<b>SERVICE</b>	<b>B0403001</b>
<b>BULLETIN</b>	<b>2004-02</b>

Subject: Consumer Z Steering cable connectors

Models Affected: 968999219, /CZ4815AA, 968999220/CZ4817KOA  
Consumer Zero Turn Mower, all serial numbers

Figure 1 (lower swivel in IZT unit)

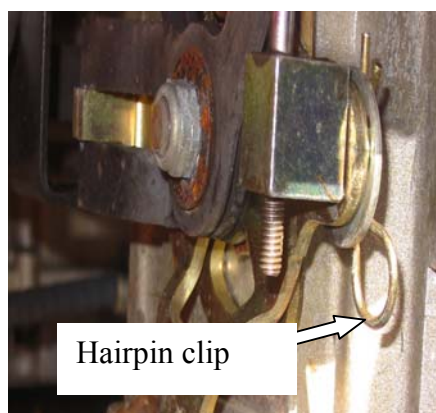
Some units may have a lower cable connector installed incorrectly. The following pictures will help you determine if the ones you are working on are installed correctly. Please examine all units during setup before delivery

Locate the lower swivel where it connects to the IZT power unit underneath the frame (see figure 1). There is one for each side. Remove the hairpin clip and pull the swivel straight out. The protruding pin should be on the lower end of the block (see arrow in figure THREE) and completely bottomed out. The swivel has a counter-bore on the topside, which should slide onto the cable first. The swivel must then be threaded all the way up until the counter-bore bottoms out. Figure 2 shows an incorrectly installed swivel (notice the difference in pin position and amount of threads showing from figure two to figure three). If your unit has the swivel installed correctly reassemble the swivel and put the hairpin back in place. If your cable swivel is installed incorrectly please refer to bulletin 0303022. which covers all aspects of cable adjustment.
